**IEEE P802.11
Wireless LANs**

Proposed Protocol Identification updates to IEEE Std 802				
Date: 2024-01-08				
Author(s):				
Name	Affiliation	Address	Phone	email
Roger Marks	EthAirNet Associates	4040 Montview Blvd Denver, CO 80207	+1 802 capable	roger@emarks.net
Mark Hamilton	Ruckus/CommScope	350 W Java Dr. Sunnyvale, CA 94089	+1-303-818-8472	mark.hamilton2152@gmail.com

Proposed updates to IEEE Std 802, on the issue of protocol identification, for consideration in the Working Group Letter Ballot recirculation of P802-REVc/D1.2.

Figure 6—LLC sublayer in 802 RM

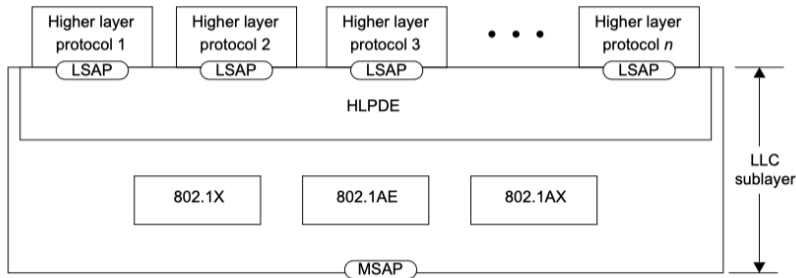
~~experimental protocol identifiers under the Local Experimental EtherType, as described in 9.2.3.~~

~~LPD/SNAP should not be used with Length/Type encoding. Length/Type encoding, using the LLC encapsulation EtherType of IEEE Std 802.1AC, allows LSAP protocol identifiers to be encoded even when the value of the Length/Type field indicates EPD.~~

Two methods may be used in the HLPDE. The two methods are:

- 1) EtherType protocol discrimination (EPD), which uses, as the protocol identifier, the EtherType value made available to the LLC sublayer through the MSAP; and
- 2) LLC protocol discrimination (LPD), which uses, as the protocol identifier the LLC address as specified in ISO/IEC 8802-2 or, using a particular form (described in 9.4) of the Subnetwork Access Protocol (SNAP) format, an EtherType.

New IEEE 802 standards shall support protocol discrimination in the LLC sublayer using EPD. IEEE 802 standards should support protocol discrimination in the LLC sublayer using LPD.
